Proposed VSW1 CPZ Wool Road Area — formal consultation.

Subject: Proposed VSW1 CPZ Wool Road area – formal consultation.

Appendix 1 – Drawing No. Z78-345-01 rev A

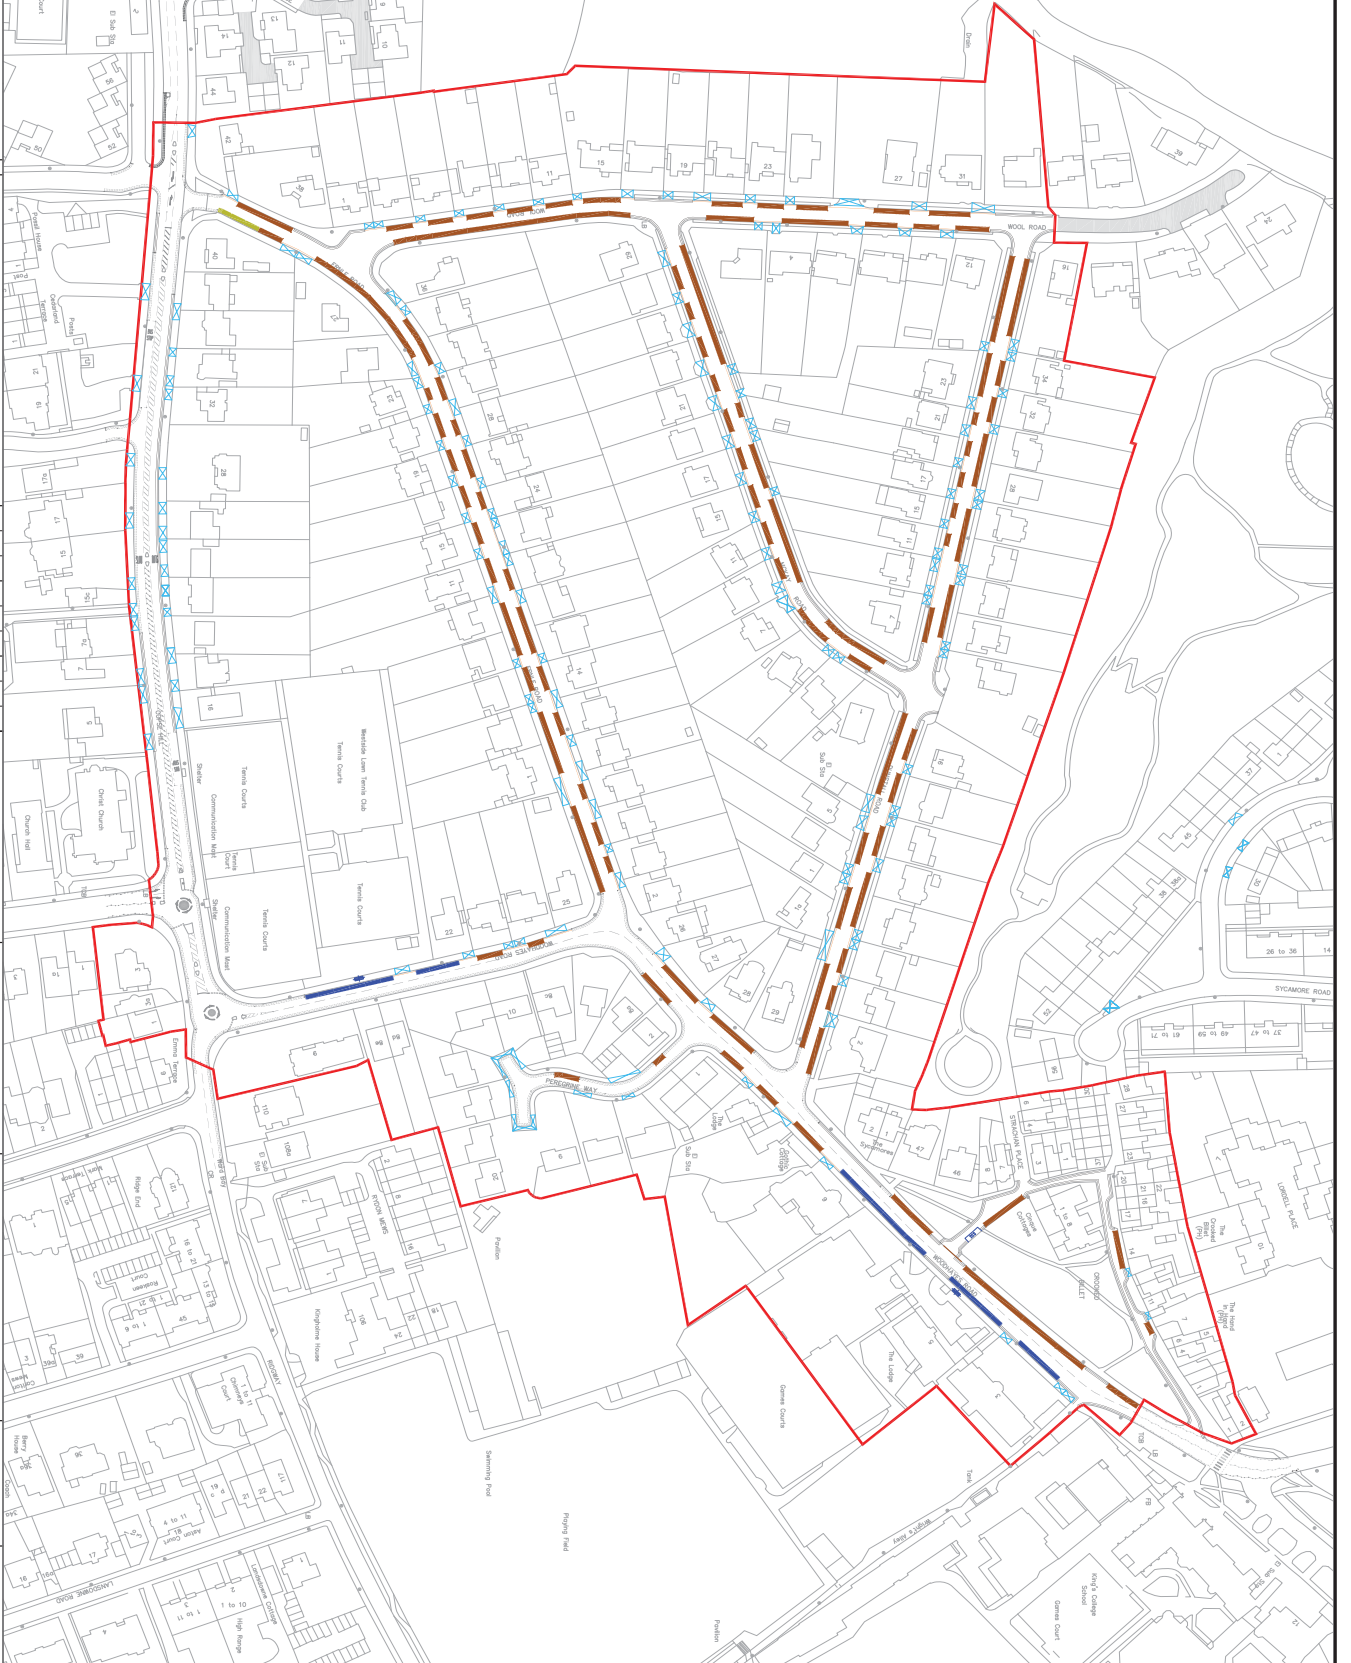
There are few spaces where one can pull in on Ernle Rd to allow a car coming from the opposite direction to pass as residents find they have to ask visitors to park across their own drives. On looking at the planned parking changes there are a few errors on Ernle Rd where drives are not indicated meaning that the number of proposed parking spaces will be slightly less. There also appears to be no planned parking restriction on Copse Hill outside Christ church which means that parking for congregation members attending week day services or funerals will be even more problematic. If the CPZ is agreed and goes ahead and parking permits are made available to School Employees and Tennis club members, could the place where parking is available to these be stipulated?

2. I see from the proposed plan than the parking is intended to be permitted on both sides of McKay Road adjacent to No3 and No5. I would encourage your colleagues to see if that is compatible with being able to go in and out of driveways as the roadway is not wide. At the very least there needs to be a restriction on how close cars can park to driveways otherwise there is insufficient room to swing in or out - especially when moving backwards. I would suggest a couple of metres at least.

However, we would question why, with 55 properties in Crooked Billet, only 8 spaces are proposed when at present we are able to comfortably park 16 cars. We are disappointed with the proposed loss of the two spaces by 9 Strachan Place. One maybe but surely not both? And indeed the loss of a further three spaces where the Crooked Billet adjoins Woodhayes Road opposite Kings Sports Hall. Obviously, we need a disabled bay but surely it does not need to take up the whole area which at present is used to park up to three cars?

6. First, not all Woodhayes Rd residents have off-street parking. Your plan of the roads and residences pictures my residence 6 Woodhayes Rd as having an on-site off-street parking space and cross-over. This is UNTRUE. Your plan ignores the existence (since the 1960s) of the two other residences 6a and 6b; I understand that the forecourt in question is associated with 6a, leaving 6b also without contiguous off-street parking.

- 4) I see that, as usual, Merton is proposing to reduce valuable parking capacity by introducing yet more double yellow lines in Woodhayes Road. There is no need to extend the double yellow lines to outside 47 Crooked Billet. Just after the totally unnecessary dropped kerb that your engineer and your traffic wardens are so obsessed about would be sufficient. If the argument is to smooth traffic flow, my response would be that anything that calms the traffic would be useful. In that email, I pointed out that I was informed by the engineer that Merton does not care about the impact of CPZ's on businesses. I had in mind the impact of the CPZ on the pubs (Crooked Billet and Hand in Hand) and the sports clubs (Kings and Westside).

Within a CPZ (during the operational hours of the zone), parking activity is regulated along every inch of kerb space. Yellow lines are proposed where parking must not take place e.g. around junctions, outside schools, at crossovers which give access to properties. The design of the CPZ will remove inconsiderate and obstructive parking from the area.

The section of Copse Hill within the VSW1 CPZ, the proposal is to install double yellow lines apart from the single yellow line proposed for outside the Christ Church. This will remove inconsiderate and obstructive parking along this section of the road.

The section of Copse between Nos 5 and 42 have crossovers as a result there is not enough kerb space to add parking bays without obstructing residents' driveways and visibility.
